WCAP-16793-NP, Rev. 0 (Non-Proprietary)
Project No. 694

OG-07-477

Subject: Pressurized Water Reactor Owners Group
Responses to the NRC Request for Additional Information (RAI) on WCAP-16793-NP, "Evaluation of Long-Term Cooling Considering Particulate, Fibrous and Chemical Debris in the Recirculating Fluid" (PA-SEE-0312)

Figure 2-1: Schematic of Fuel Assembly Fibrous Debris Capture Test Loop

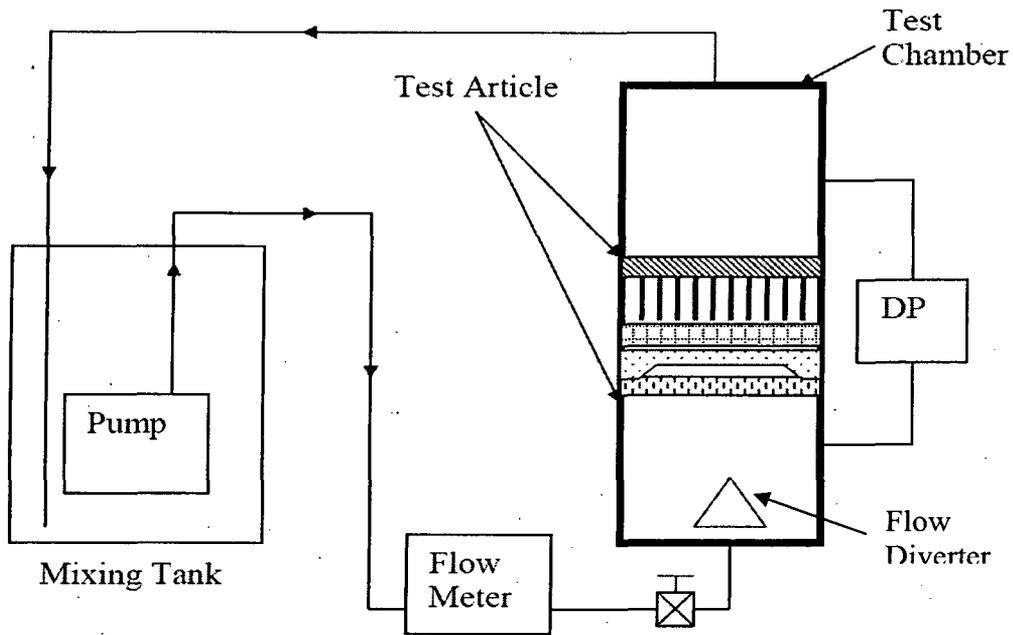
On page 2-3 it is stated that recent observations from testing of a partial-length fuel assembly using plant-specific fibrous and particle debris have confirmed that the NUREG/CR-6224 correlation is quite conservative for application at the core inlet. Please provide a complete description of this test facility, the tests that were performed and the results.

A schematic of the test loop is shown in Figure 2-1 below. The test article was mounted approximately 12 inches above the bottom of a Lexan test chamber. Flow entered from the bottom of the chamber. An inverted solid circular cone directed flow along the bottom of the chamber to minimize the settling of debris. Flow exited the top of the chamber and returned to the mixing tank. The taps for a differential pressure transmitter were connected to the test chamber above and below the test article. The mixing tank allowed debris to be added to the system near the pump suction.

Figure 33-1 Comparison of LOCADM and SKBOR Calculated Core Region Boric Acid Concentration

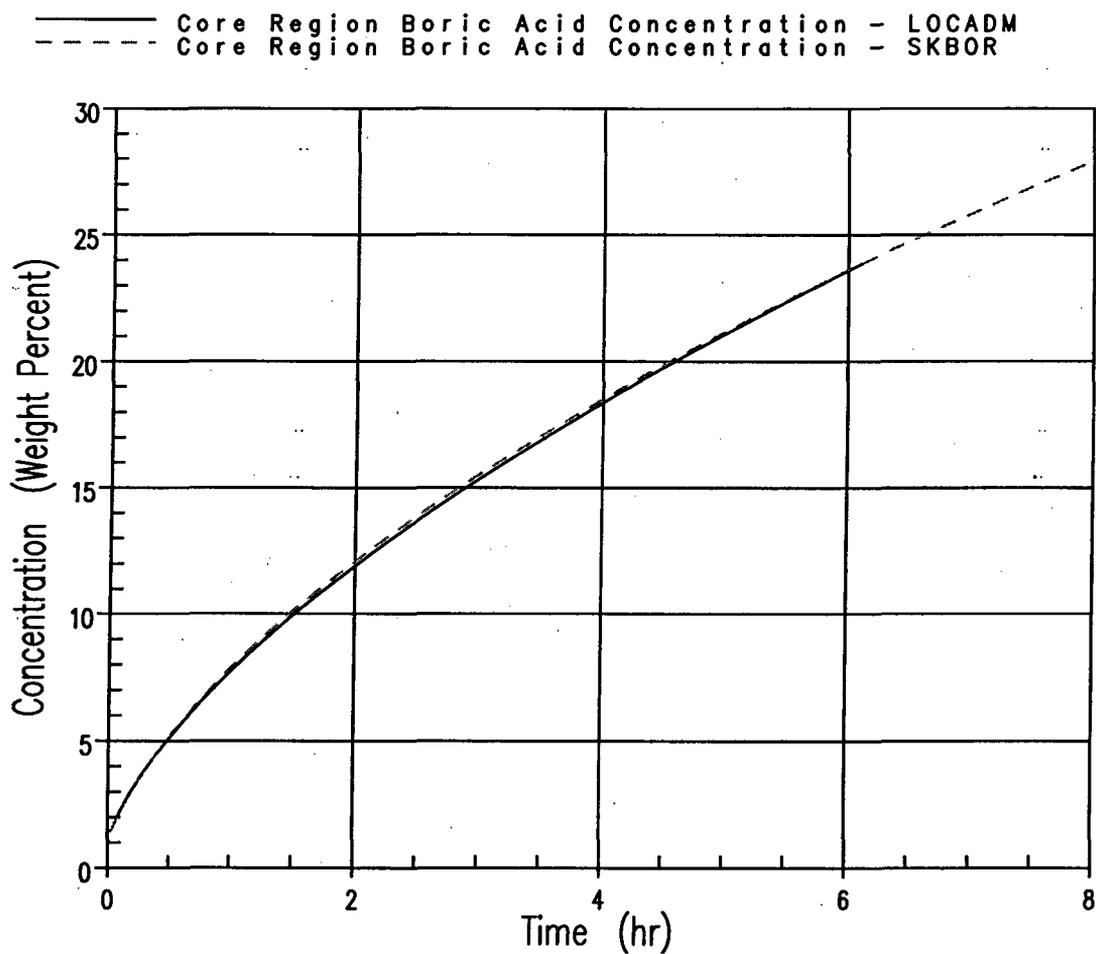
On page E-15 a comparison of the results by the LOCADM computer code and the SKBOR computer code are described for a post-LOCA boric acid concentration calculation. Please provide more details of this comparison including core boric acid concentration as a function of time. Provide a reference available to the NRC staff describing the SKBOR computer code and including any review and approval by the NRC staff.

The table and figure below show a comparison between the results for SKBOR and LOCADM.

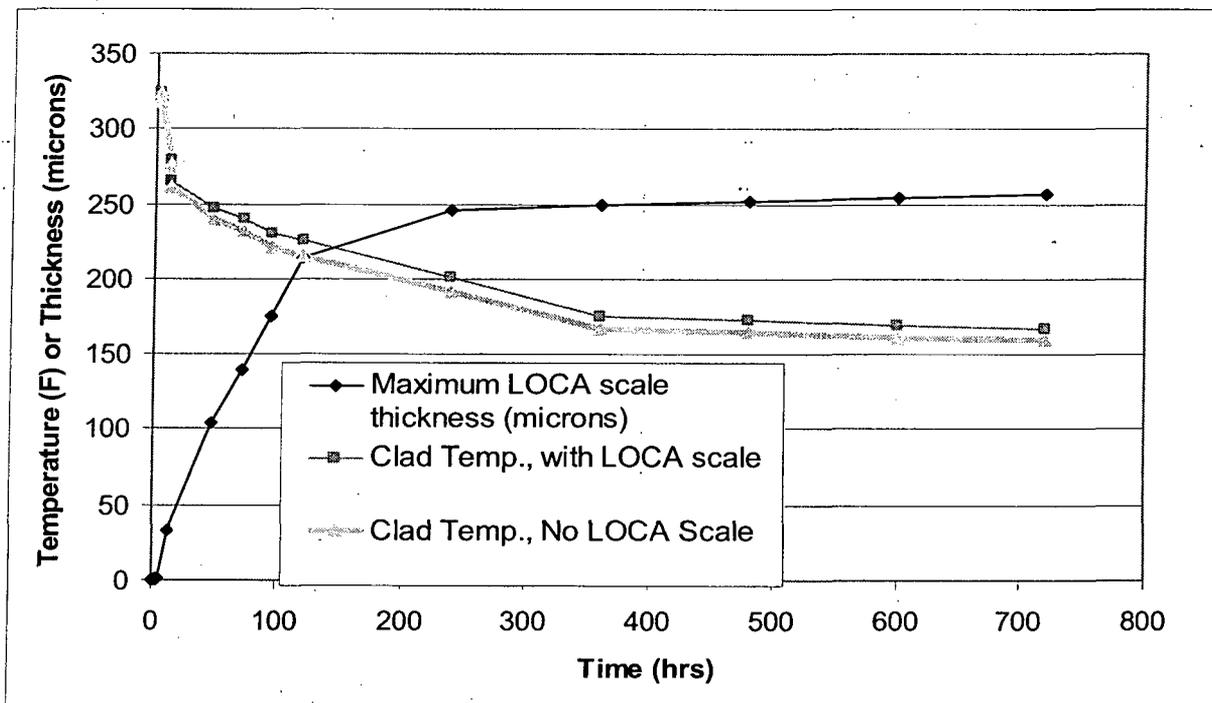
Page 5-9 - In Figure 5-3, please show what the fuel cladding temperature profile would look like for a case with no debris contamination at the fuel surface?

The fuel cladding temperature with no LOCA scale has been plotted above. Other parameters such as core power, initial crud thickness, etc., were the same as in the original WCAP example.

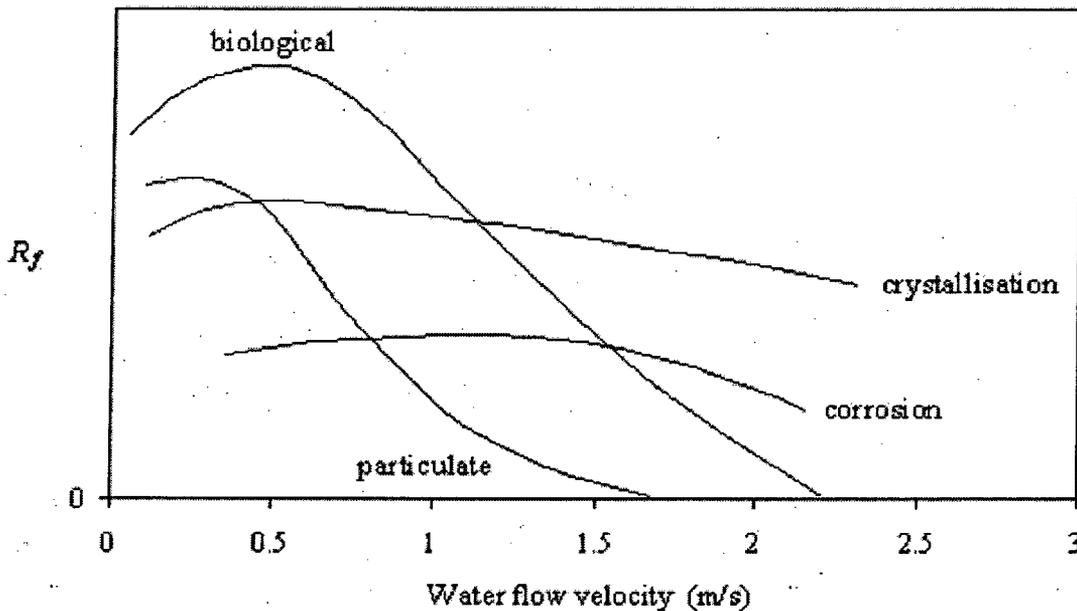
Page E-3 - Can it be shown that precipitate deposition on the residual heat removal heat exchanger surfaces will not lead to reduced flow and heat transfer such that the maximum fuel clad temperature assumption of 800 °F will not be exceeded? The topical report indicates that all debris and precipitate is transferred to the vessel. Please demonstrate that a drop in the heat exchanger flow is not a more conservative assumption based on reduced heat exchanger cooling capability.
